Re: Minor Modification to the Resource Recovery and Protection Plan (R2P2), 5th Left Longwall Panel Length Reduction, Skyline Mine

Request
For
R2P2 (Resource Recovery and Protection Plan) Modification
(One Mining Area)

Re: Skyline Coal Mine, Federal Coal Lease UTU-67939
Projected 5 Left Longwall Panel

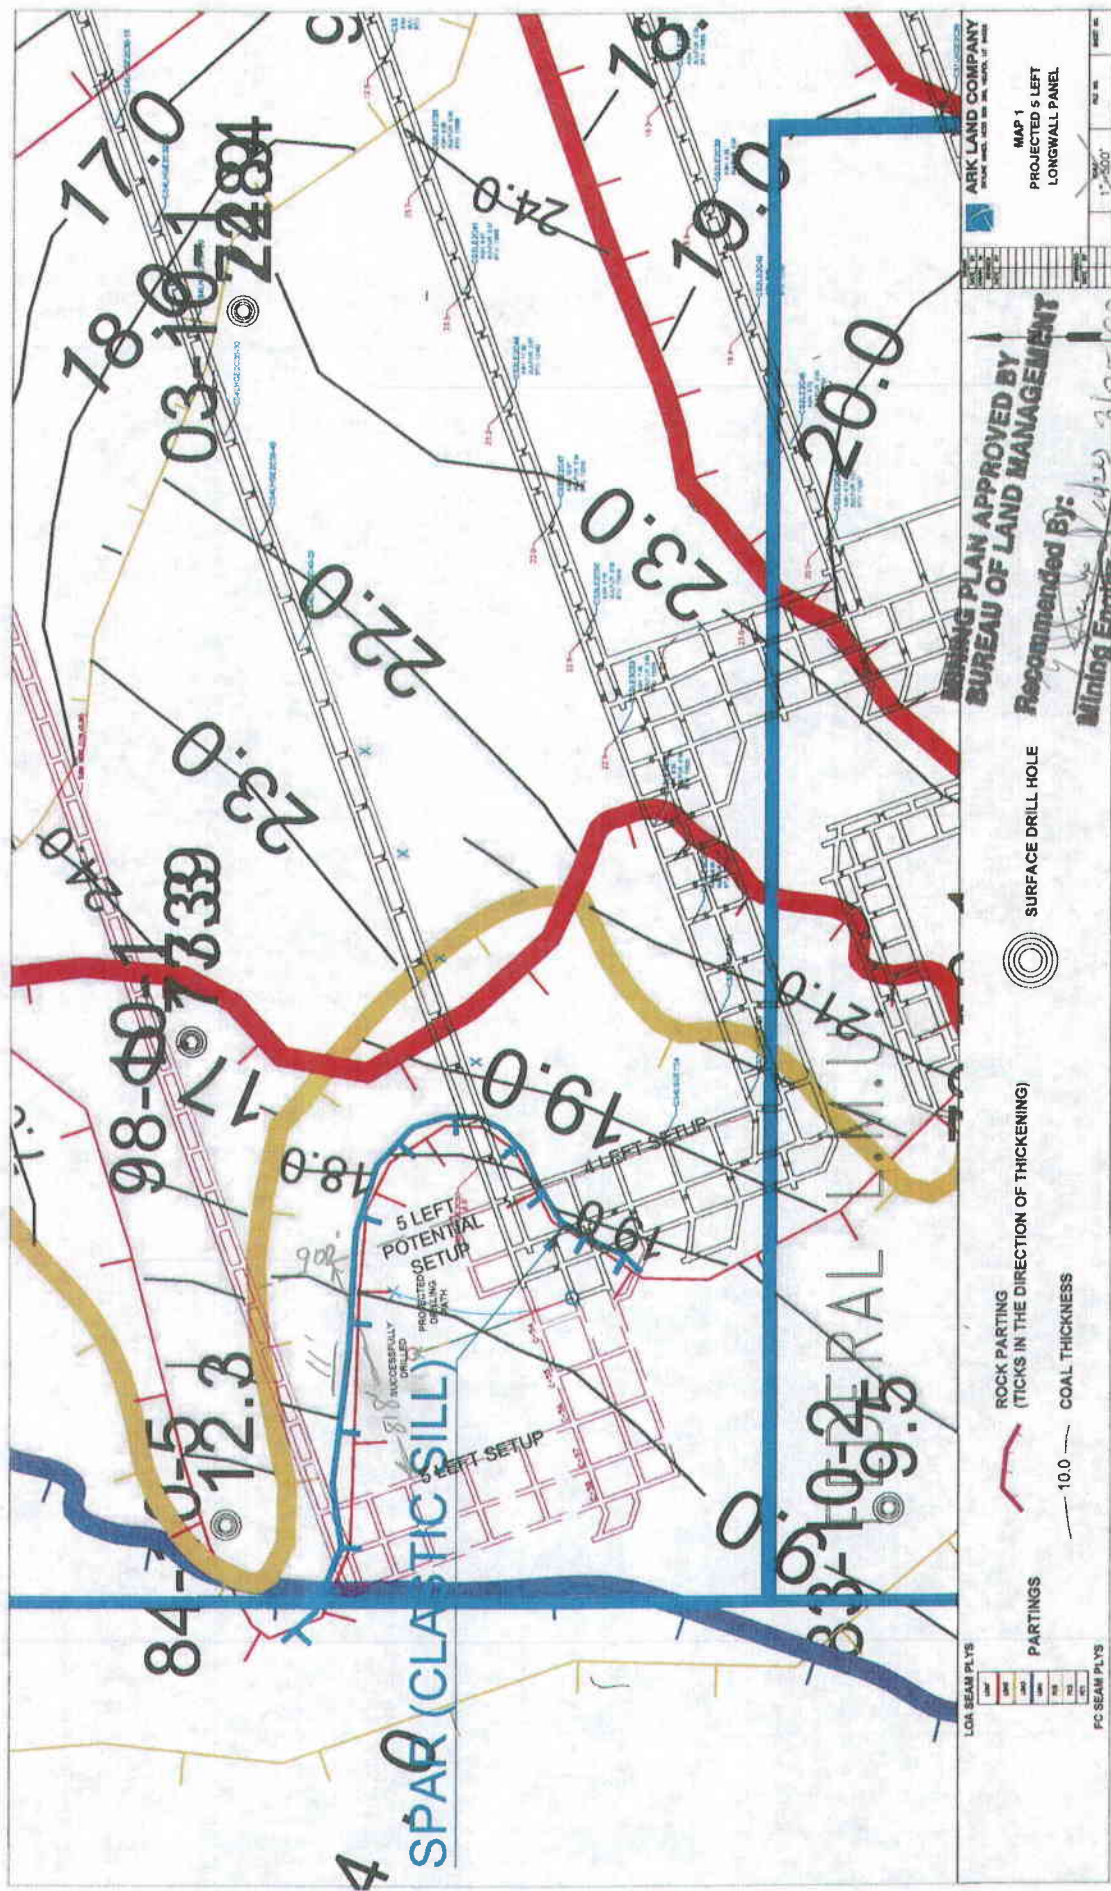
Proposed Plan: Canyon Fuel Company, LLC plans to terminate the development of the 4th Left entries at crosscut 53. A rock parting, or "spar" has been encountered in the upper part of the Lower O'Connor "A" seam which rapidly thickened from zero to more than 36 inches. The 4th Left longwall panel will be mined as planned; however, with the advent of the spar, the 5th Left Longwall will be shortened by 850 feet. The proposed bleeder and set-up entries for the 5th Left panel will be driven at a similar location as they were driven for the 4th Left panel.

Proposed Plan (Including effect on coal recovery): Proposed plan is to try to mine the 5 Left setup room at crosscut 51 of the 4 Left longwall headgate. This will shorten the 5 left panel by approximately 850 feet. The reserve tonnage involved is approximately 350,000 tons. As additional drilling is performed to evaluate the rock spar, the 5 Left setup room may need to move to crosscut 50 or even to crosscut 49.

Skyline Mine has been successful in driving the 4 Left longwall panel for the full length that was planned. However, just prior to the conclusion of the development of the headgate entries, a rock spar sill was encountered in the upper part of the Lower O'Connor 'A' seam. This spar rapidly thickened from zero to more than thirty (30) inches at the termination of headgate mining. See Map 1.

As the 4 Left headgate is also the tailgate for the planned 5 Left longwall panel, it was planned to extend the 4 Left headgate entries another 850 feet to the west to serve 5 Left. The encounter with the spar caused Skyline Mine to, instead, drill a horizontal exploration hole to the northwest (perpendicular to the longwall block) to explore the spar. At approximately the center of the 5 Left longwall panel and 400 feet outby the 4 Left setup room, the drill hole indicates the spar is in excess of five (5) feet thick.

Approval: The BLM agrees with the proposed change to move the setup room for 5 Left longwall panel to cross cut 51. The thickness of the rock, its placement within the seam, coupled with the difficulty in separating the rock from the coal, preclude effective mining inby crosscut 53. The rest of the overall mine plan will not be affected by this change. A copy of the approved mine map is enclosed. Should it appear to be necessary to move the setup room outby

to cross cut 50 or 49, please notify our Price Field Office as soon as possible for another review and consideration of an additional mine plan change.
